CERTIFICATE OF APPROPRIATENESS

Property: 7706 Rockhill St., Lot 4, Block40, Glenbrook Valley Subdivision. The property includes a historic single-family ranch home with a 2 car attached garage, situated on a 7,475 square foot lot.

Proposal: Alteration – Replace seven original windows and three original doors.

HPO File No. 160329

WEST SIDE WINDOW D (NORTH)

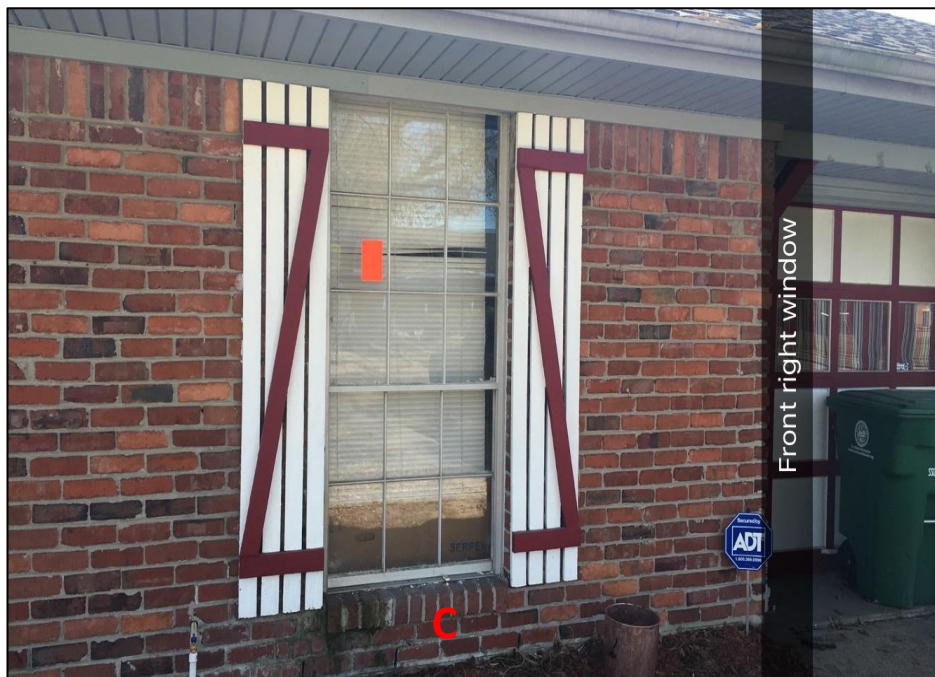
- ☐ ☒ ☐ (1) The proposed activity must retain and preserve the historical character of the property;
The proposed new windows retain the historical character of the existing property; however the proposed door is not compatible with the character of the property. Additionally, our online preservation manual notes 'Victorian-style beveled glass doors' as being incompatible. The existing door is original to the structure and should be retained and not replaced

Recommendation: Partial Approval: Approval for new 1-over-1 vinyl windows and denial for replacement of the existing doors.

FRONT DOOR 1

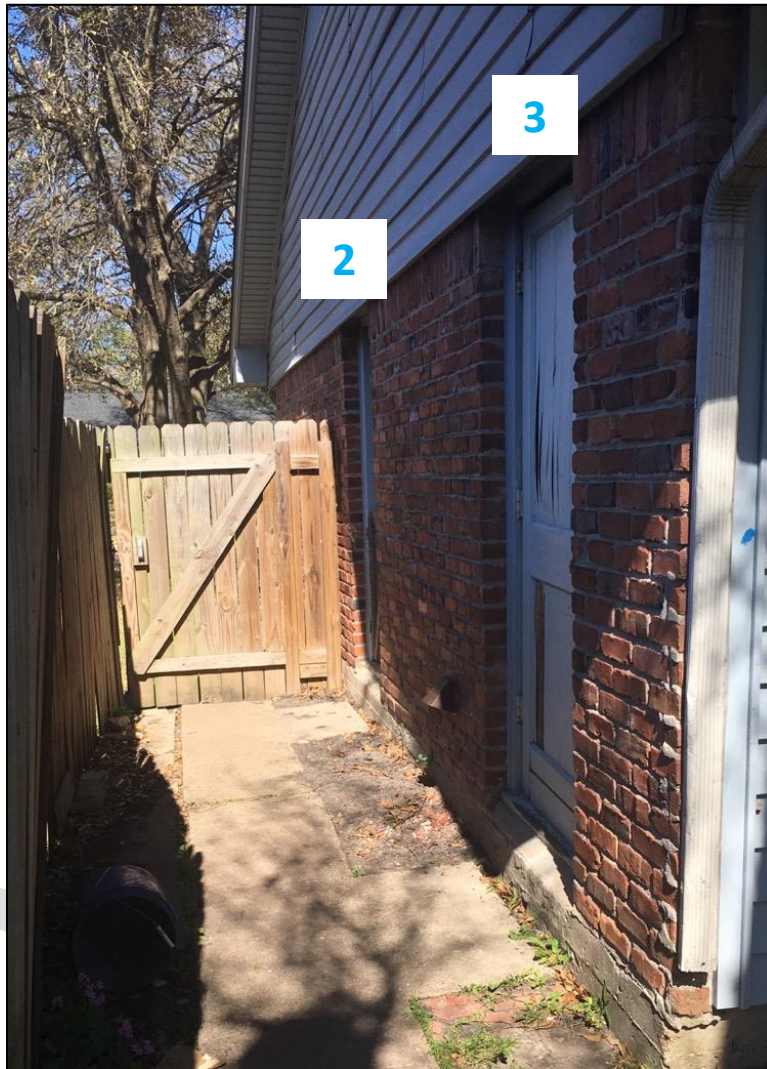
- ☐ ☒ ☐ (4) The proposed activity must preserve the distinguishing qualities or character of the building, structure, object or site and its environment;
The proposed new windows retain the historical character of the building and its environment; however the proposed door is not compatible with the character of the property. Additionally, our online preservation manual notes 'Victorian-style beveled glass doors' as being incompatible. The existing door is original to the structure and should be retained and not replaced

- ☐ ☒ ☐ (7) The proposed replacement of missing exterior features, if any, should be based on an accurate duplication of features, substantiated by available historical, physical or pictorial evidence, where that evidence is available, rather than on conjectural designs or the availability of different architectural elements from other structures;
The proposed new windows retain the historical character of the existing property; however the proposed door is not compatible with the character of the property. The existing door is original to the structure and should be retained and not replaced, if the door is damaged beyond repair, the new door should be similar to the existing door.
